Ford and International 6.9 Diesel Engines—Mandatory Spacer

Ford & International 6.9 Liter Diesel engines CARDONE Part 59-8304 & 59-8305

WATER PUMP MOUNTING BOLT LENGTHS & LOCATIONS

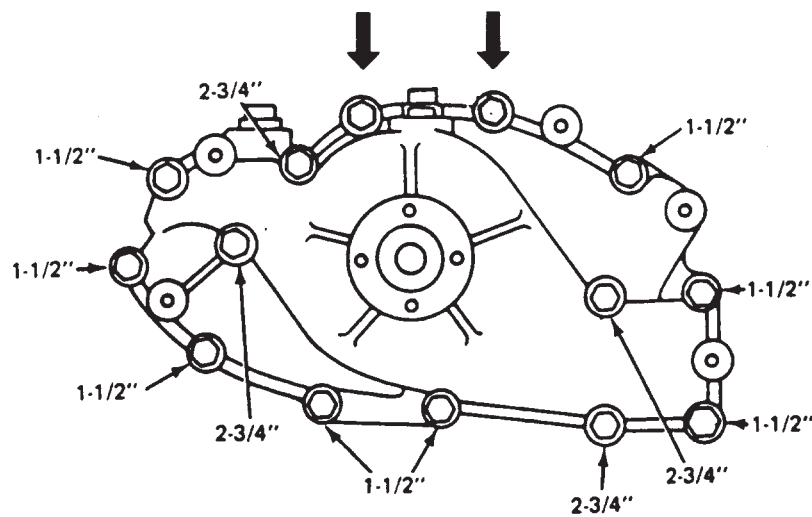
If the mounting flange on the original pump is 1-1/16" thick at the top two mounting holes and if the replacement unit is 13/16" thick, you must use two 1/8" spacers or 1-1/4" bolts.

IF THIS IS NOT DONE, INJECTOR PUMP FAILURE WILL OCCUR AND VOID THE WATER PUMP WARRANTY.
